TRUCK, TANK, WATER, HEAVY, MC3, MACK

TANK COMPARTMENT DELIVERY PIPES

MODIFICATION INSTRUCTION

Figure 1 – Compartment Pipes Flex Pipe Locations

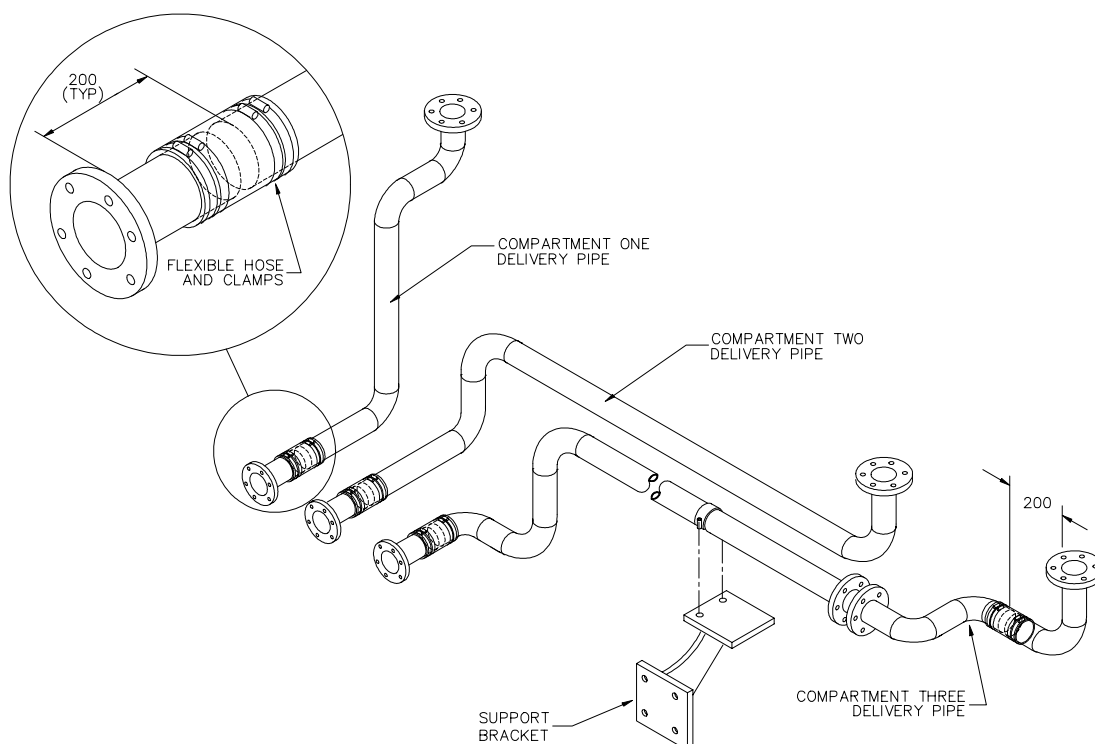
1. The tank compartment delivery pipes are prone to cracking in the area near the manifolds and at the first bend on compartment three delivery pipe, where it comes out of the tank. The pipes are all rigid mounted and the cracks are caused from vibration as a result of tasking on rough unpaved roads.

- a. Cut compartment one, two and three delivery pipes (using hand-held hacksaw with an 18 TPI blade), 200 mm from the delivery pipe to manifold flange, as shown in Figure 1.

- g. Cut compartment three delivery pipe (using hand-held hacksaw with an 18 TPI blade), 200 mm forward of the last bend, as shown in Figure 1.
- h. Remove 40 mm of pipe from rear piece of compartment three delivery pipe, which attaches to the base of the tank, at the point where the first cut was made.

- k. Fit hoses (Item 4, Table 1) to compartment one, two and three delivery pipes at manifold end of pipes at the point where the pipes were cut.
- l. Place four clamps (Item 5, Table 1) over each piece of hose.

Ensure that there is a 40 mm gap between the end of each pipe, under the flex hose to allow pipe to flex.

- t. Drill four 12 mm holes in the left hand subframe for compartment three support bracket (Figure 2).
- u. Mount support bracket (Item 6, 7 and 8, Table 1) from inside of subframe to compartment three delivery pipe (Figure 1).
